RESPONSE TO SUBMISSIONS (BUILT HERITAGE) SUPPLEMENTARY LETTER - LINDFIELD LEARNING VILLAGE

Urbis has been engaged to prepare this response to submissions for State Significant Development Application SSD8114, which involves additions and alterations to the former UTS Ku-ring-gai Campus (originally the William Balmain Teachers College). The subject site is located on Eton Road in Lindfield and identified as an item of local heritage significance by Ku-ring-gai Council, item: I422 (Ku-ring-gai Local Environmental Plan 2015).

Figure 1 – Proposed tree removal.

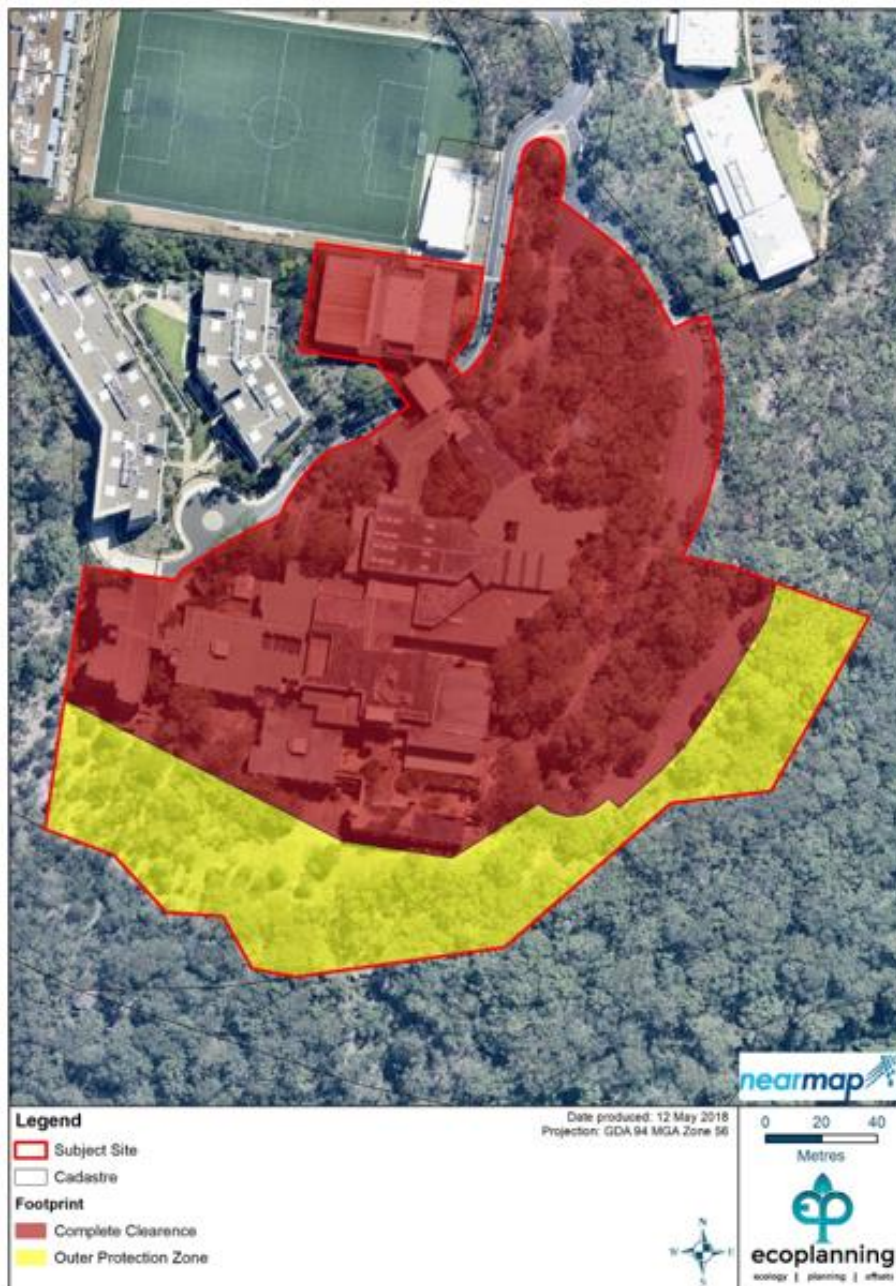
In order to establish a 100m APZ around the perimeter of the Partial School, Urbis has been advised that significant tree removal will be required across portions of the site as illustrated in **Figure 2**. For the purposes of the Biodiversity Assessment (refer **Appendix K**) and to assess the worst-case scenario, complete tree removal within Lot 2 has been considered. It is expected however, that some trees and vegetation are expected to remain within this area of the site subject to this area of the site meeting inner protection area standards.

It is appreciated that the subject proposal to remove the trees will allow for the implementation of the Phase 1 School, which will accommodate the student intake for 2019 while the appropriate measures for the reuse of the remainder of the school, from a bushfire perspective, are developed. It is also appreciated that although the trees within the immediate context of the school would be removed, the broader landscape setting would be retained and would contribute to the significance of the place.

However, it is noted that part of the design intent for the place was that the building responded to and was nestled within an untouched landscape setting. The quote below has been sourced from the assessment of significance for the item. Denuding the site of any trees will have an impact on the setting.

The subject proposal to remove trees within the zones will only allow use of the northern section of the buildings. The use of the remainder of the site may necessitate a much greater area of tree removal which will be subject to a future assessment hence the current proposal has the potential to irrevocably impact on the setting without any guarantee of enabling the full future use. Even so, it is understood that at this time, there is no perceived future use for the place without the removal of the trees as proposed and the implementation of the Phase 1 school.

- Complete tree removal is proposed under this application as a 'worst case scenario'. To mitigate some of the negative heritage impact of denuding the site of all trees Urbis strongly recommends that the number of trees for removal be considered carefully and minimised as much as possible.
- A methodology should be prepared for the installation of the fire wall in conjunction with the heritage consultant such that it is entirely reversible.

Figure 3 – Proposed playground area.

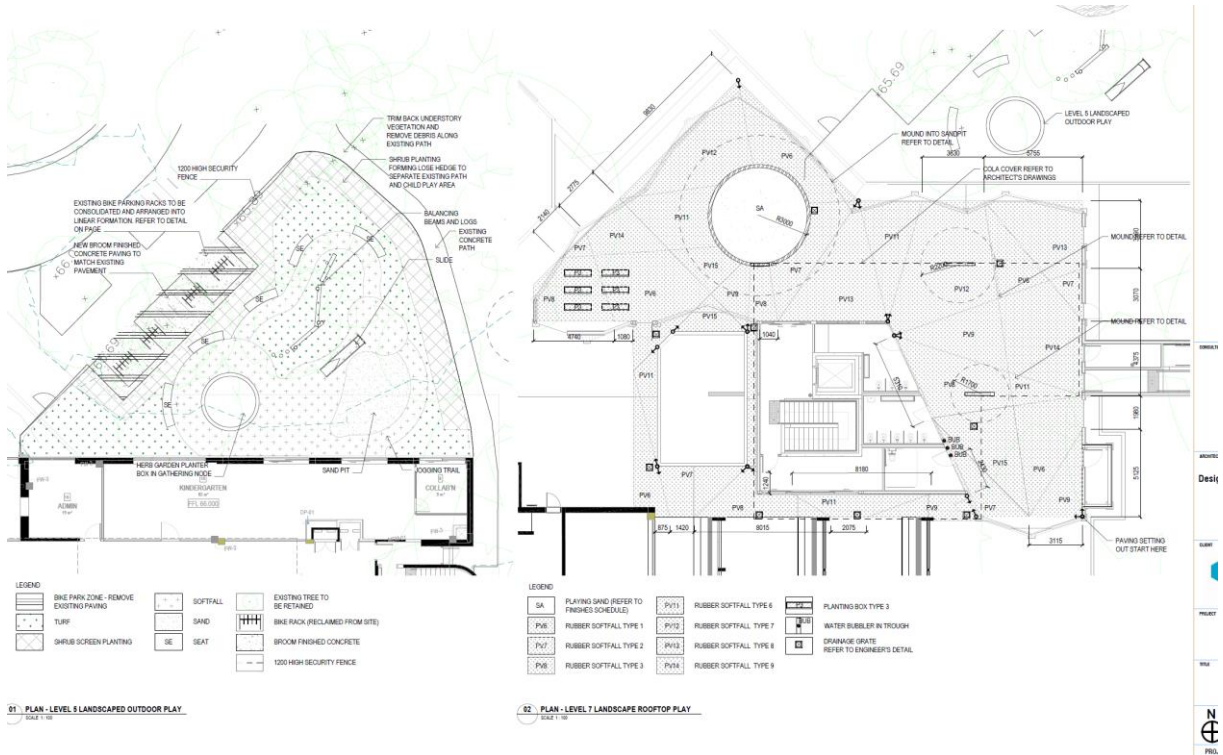
There will be some new landscaping to the immediate north of the building and roundabout to allow outdoor play by students. Concept plans have been provided to Urbis at this stage for review. It is not considered that a play area in this space would have a detrimental impact. However, the space is located adjacent to a significant and characteristic façade. It should continue to contribute to the natural bush setting of the subject building. Specifically, it should retain a predominance of native vegetation.
